NEW MIDDLE SCHOOL  
4115 VINELAND ROAD  
BAKERSFIELD  
CALIFORNIA 93306

SHEET TITLE  
**ELECTRICAL MECHANICAL PLAN BUILDING N**

SHEET IDENTIFICATION NUMBER  
**E-122N**  
SHEET OF

**RFI 139**

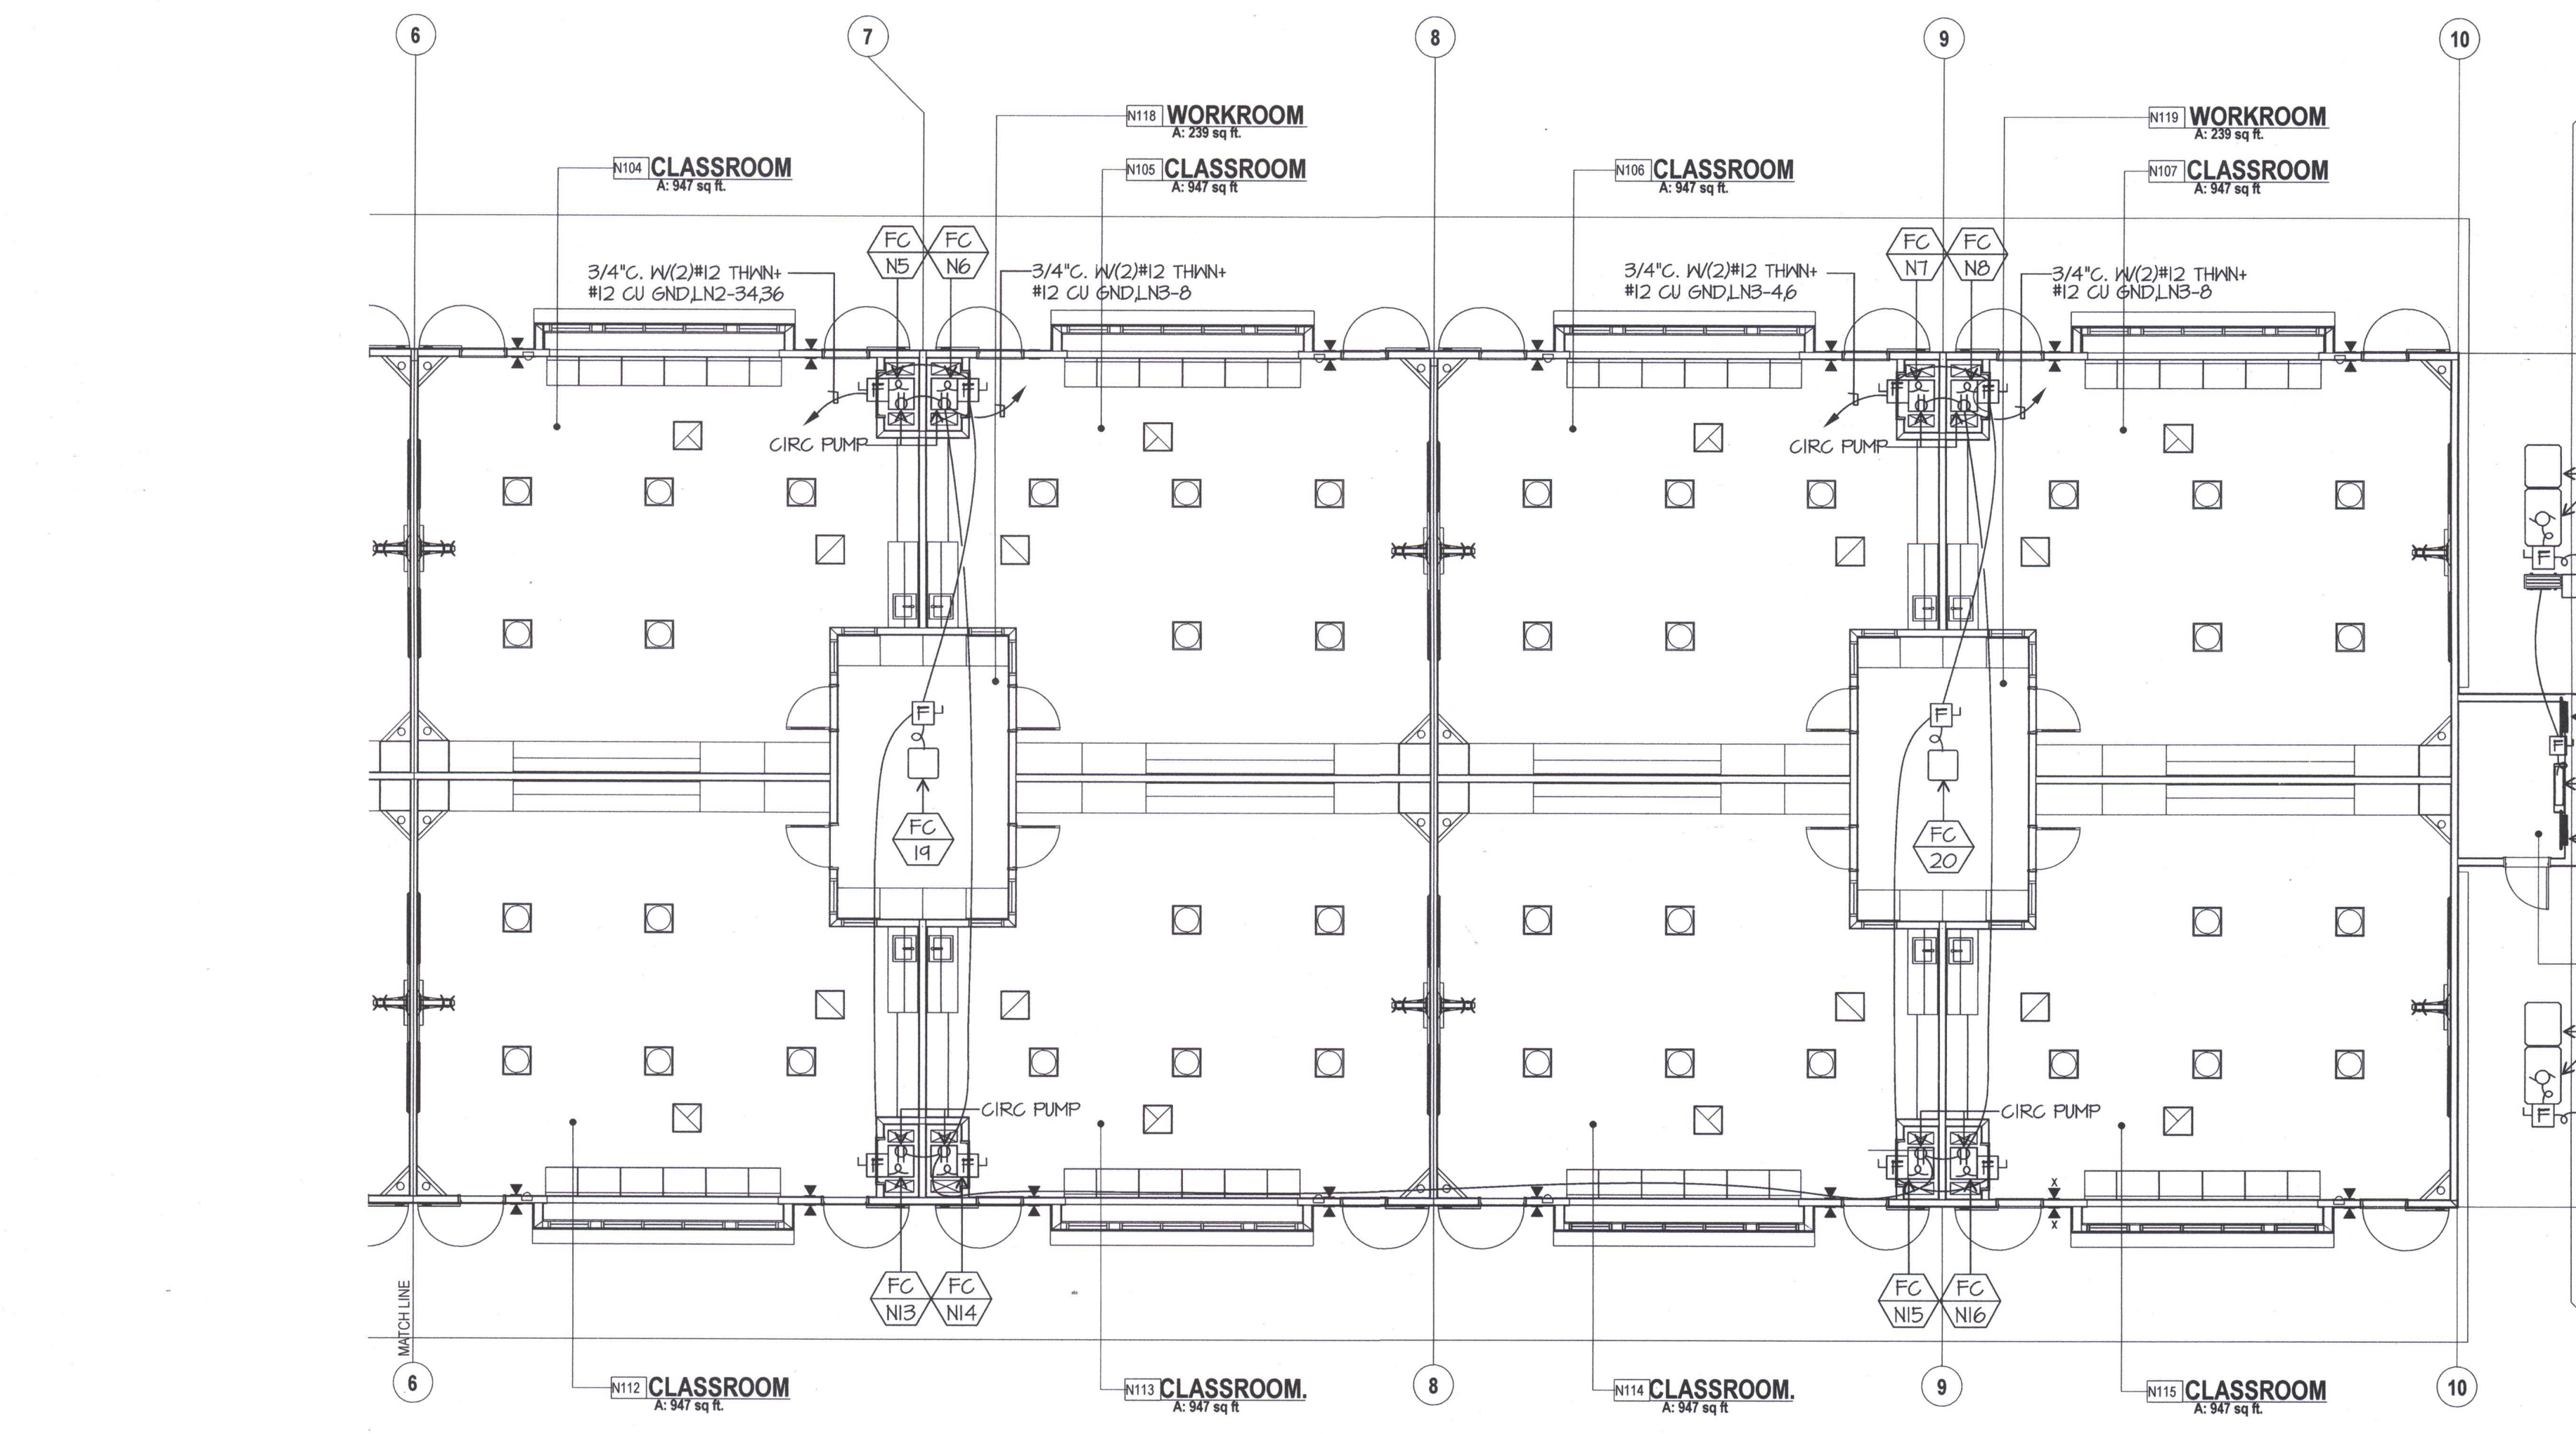
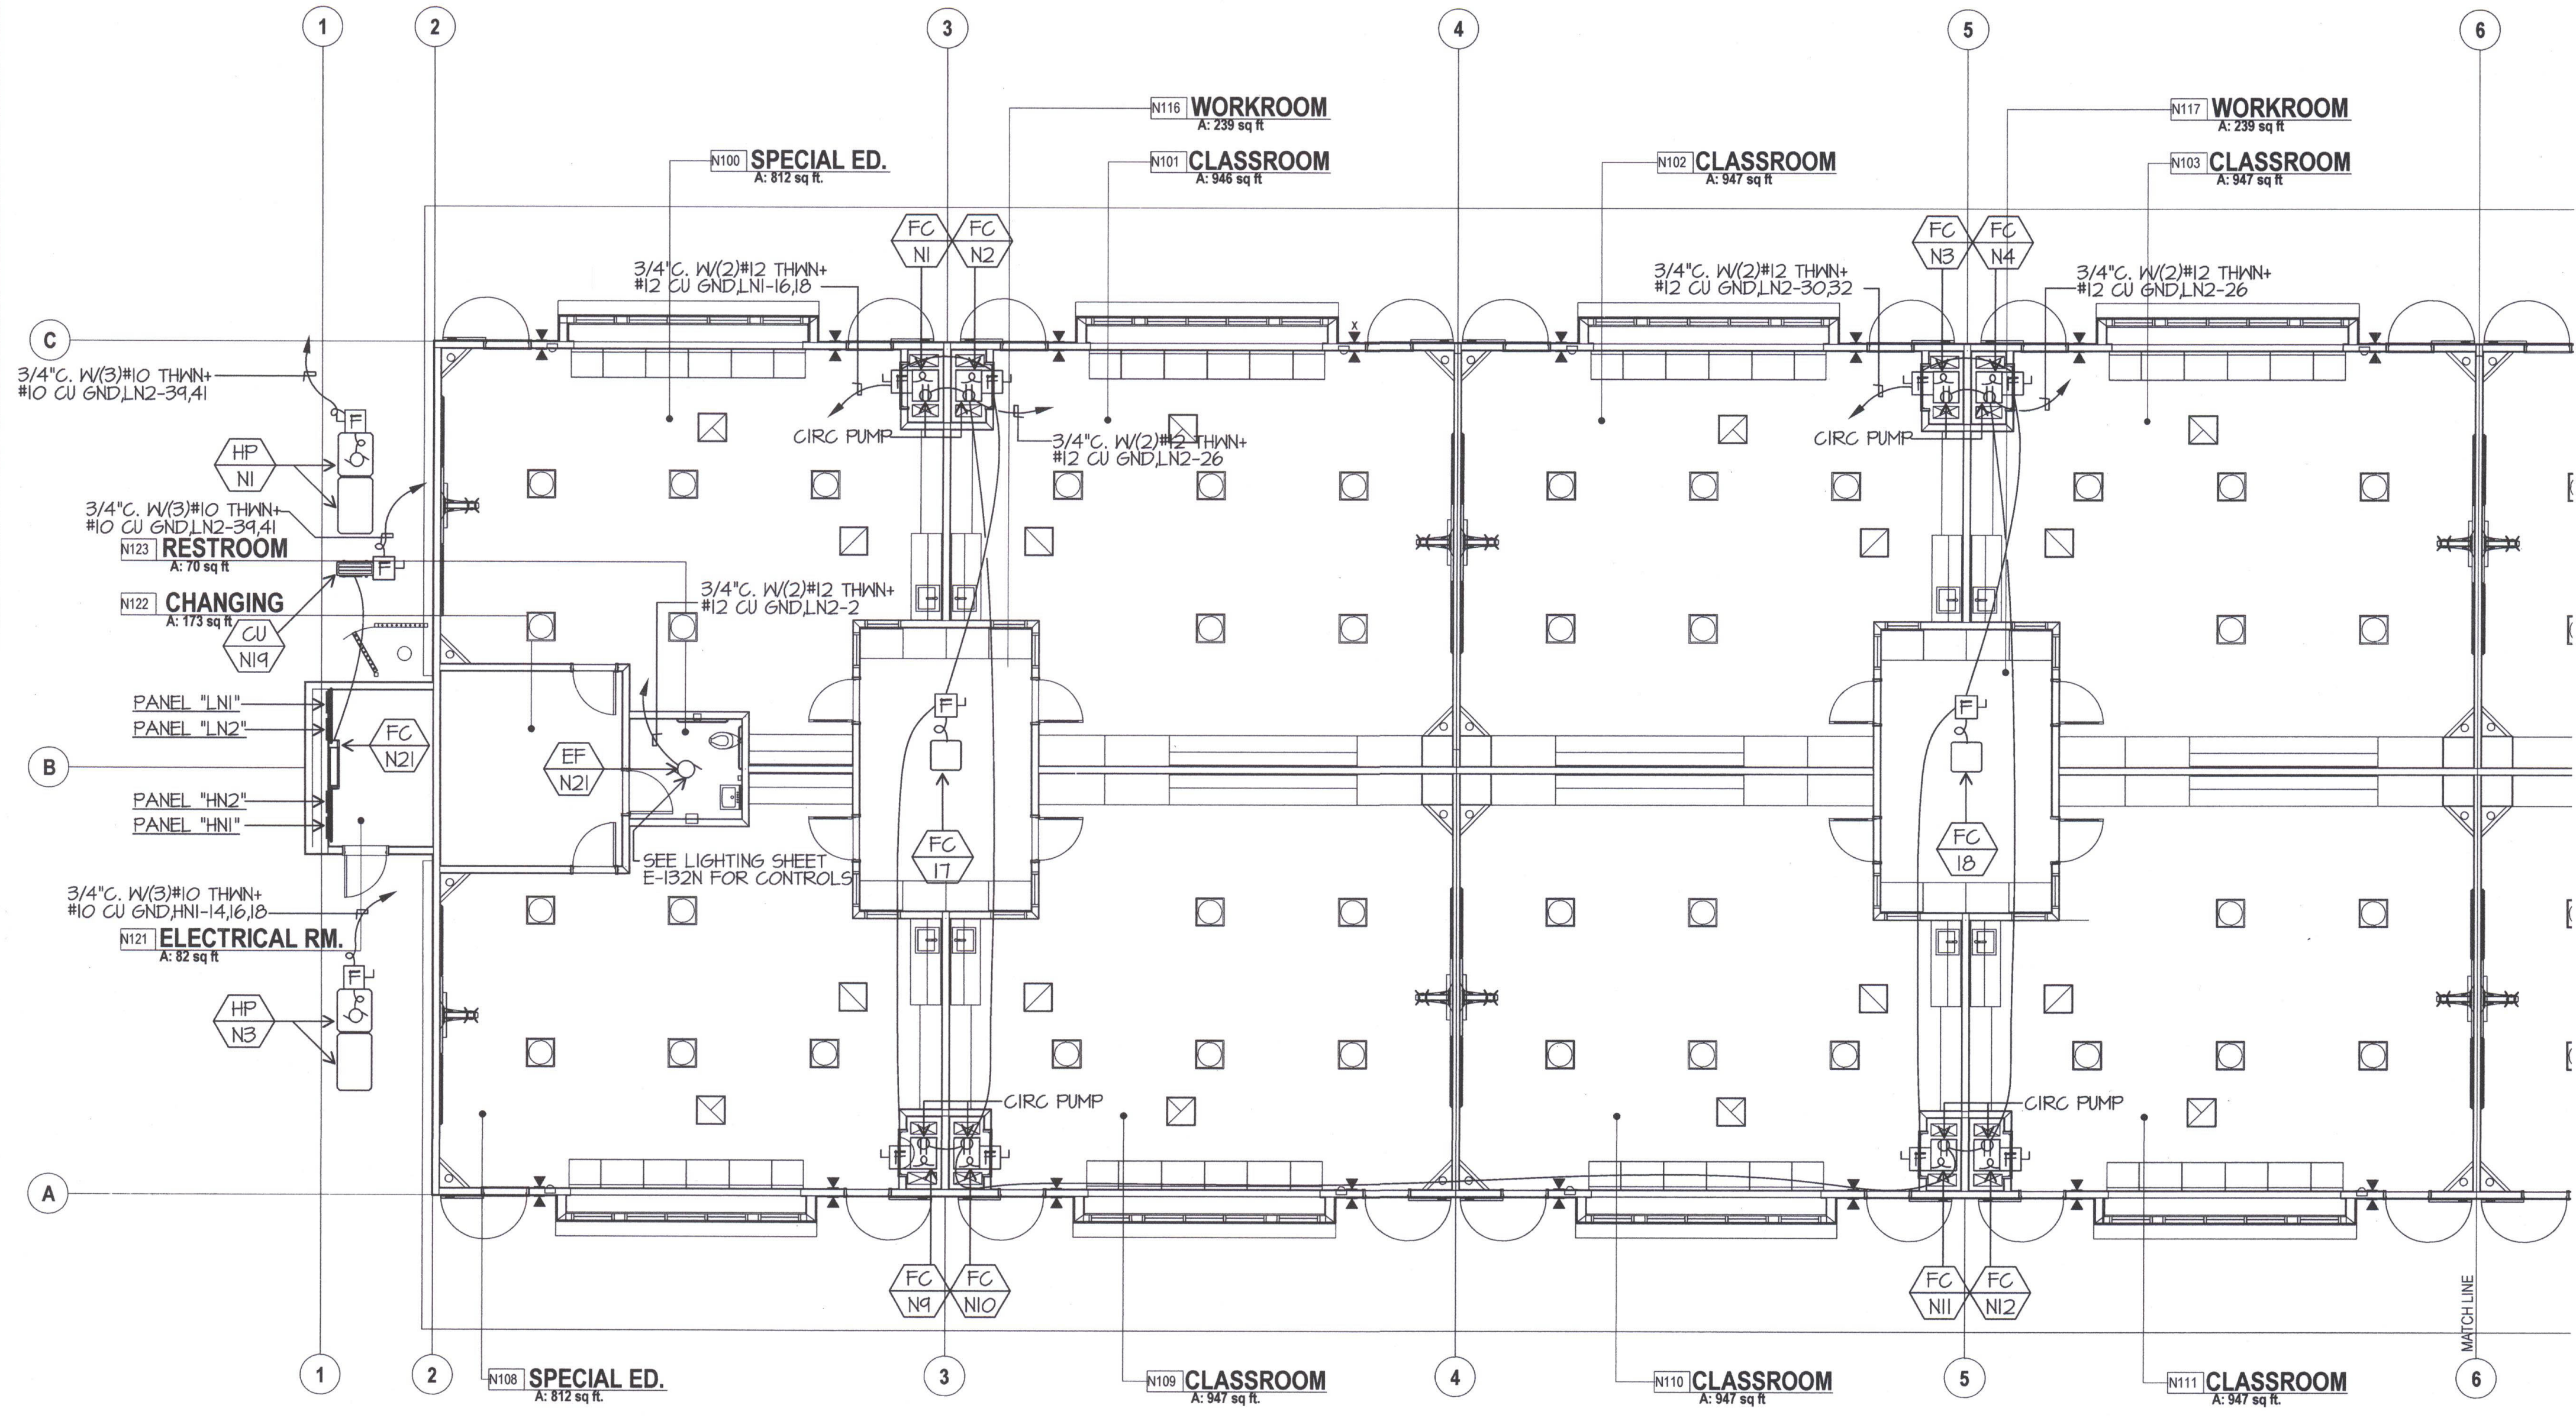
Request:  
RDM Electric - 9/18/12  
Reference Sheets E-122C, E-122D, E-122E, E-122F, E-122G, E-122H & E-122P  
In the classroom buildings (C.D., E.G., N & P), the electrical plans show fused disconnects to be installed for the fan coils. Due to the fan coils and ductwork, there is not enough room to install the disconnects inside the mechanical closets. Please advise on an alternate location for the fused disconnects for the fan coils located in the classrooms of Buildings C.D., E.G., N & P.

Answer:  
John Maloney - JMPE - 10/2/12  
It is acceptable to mount the specified fused disconnects above the ceiling.
